Access Compliance Report

Public Rights-of-Way

Intersection ID: 11958	Main Street: E_16TH_ST	Cross Street: SEIGLE_AV	Location: E
ADA ID: 9E9CE49B4CB4	Ramp Type: Perp	Initial Pass/Fail: Fail	Overall Compliance: No
			Severity Score: 21.25

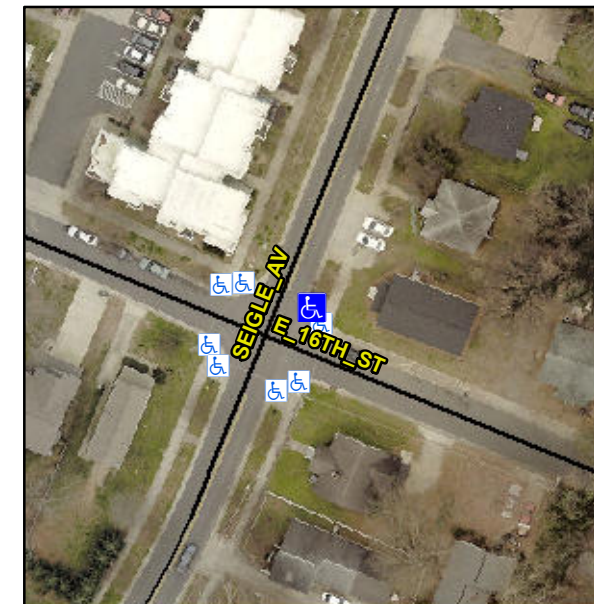
R304.5.1, R304.2.2

Compliance	Description	Data	Compliance	Description	Data
N/A	Ramp Length (in)	64.0	No	Ramp Slope (%)	9.9
No	Ramp Width (in)	47.0	Yes	Ramp XSlope (%)	0.3
N/A	Flare Type LT	N/A	N/A	Flare Type RT	N/A
N/A	Flare Slope LT (%)	N/A	N/A	Flare Slope RT (%)	N/A
N/A	Flare Traversable LT?	N/A	N/A	Flare Traversable RT?	N/A
N/A	Landing Length (in)	N/A	N/A	DWS Provided?	N/A
N/A	Landing Width (in)	N/A	N/A	DWS Contrast?	N/A
N/A	Landing Slope (%)	N/A	N/A	DWS Length (in)	N/A
N/A	Landing X Slope (%)	N/A	N/A	DWS Full Width?	N/A
N/A	Landing Curb? (Y/N)	N/A	N/A	DWS Offset (in)	N/A
N/A	Shared Landing?	N/A			
N/A	Gutter Ponding?	Yes	N/A	Gutter Slope (%)	N/A
N/A	Gutter Lip Ht (in)	N/A	N/A	Gutter X Slope (%)	N/A
N/A	Painted X Walk1?	No	N/A	Painted X Walk2?	N/A
	X Walk 1 Direction	To NW		X Walk 2 Direction	N/A
N/A	X Walk 1 Width (in)	N/A	N/A	X Walk 2 Width (in)	N/A
	X Walk 1 Slope (%)	1.0		X Walk 2 Slope (%)	N/A
	X Walk 1 X Slope (%)	1.4		X Walk 2 X Slope (%)	N/A

Remove & Replace Entire Ramp.
